STATE OF MAINE PUBLIC UTILITIES COMMISSION

Docket No. 2022-00152

CENTRAL MAINE POWER COMPANY Request for Approval of Distribution Rate Increase and Rate Design Changes Pursuant to 35-A M.R.S. § 307

BENCH ANALYSIS

Figure 6: New England. Residential Delivery Effective Rates and Post-Exclusion SAIFI of New England Utilities (2021)

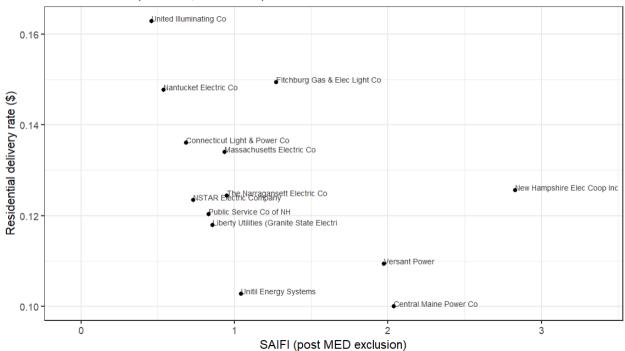
Figure 6 indicates that while CMP has the lowest residential delivery rate among all of its New England peers, it ranks below-average with respect to reliability performance, as measured by post-exclusion SAIFI. A line between CMP's current position on this chart and the New England average can suggest a potential "pathway" for CMP's incremental distribution rate increases to improve system reliability performance. This pathway is shown in Figure 7.

Figure 7: New England Average Cost of Reliability and CMP Pathway

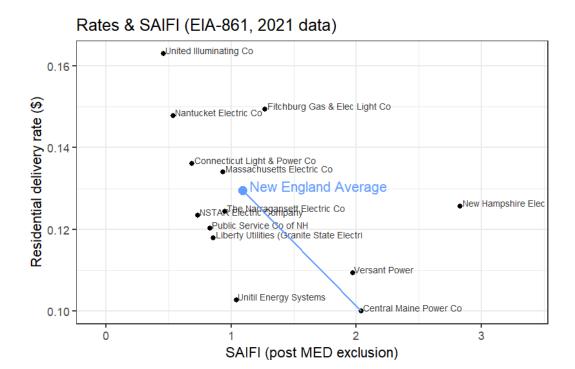
In the absence of the specific program performance expectations described above, a target could be established comparing CMP to its peers. As CMP's rates increase because of its proposed plan, one could expect that the SAIFI performance would move along the line toward the New England average. While this is a simplified analysis, it illustrates the expectation for reliability improvement achieved by additional expenditure on the distribution system. If CMP reached the New England average point in this visualization, an increase of 30 percent in effective residential rates would correlate with an improvement of 50 percent in post-exclusion SAIFI. This approach would not be as precise as the other options, but it could be used to set SAIFI expectations relative to investment.
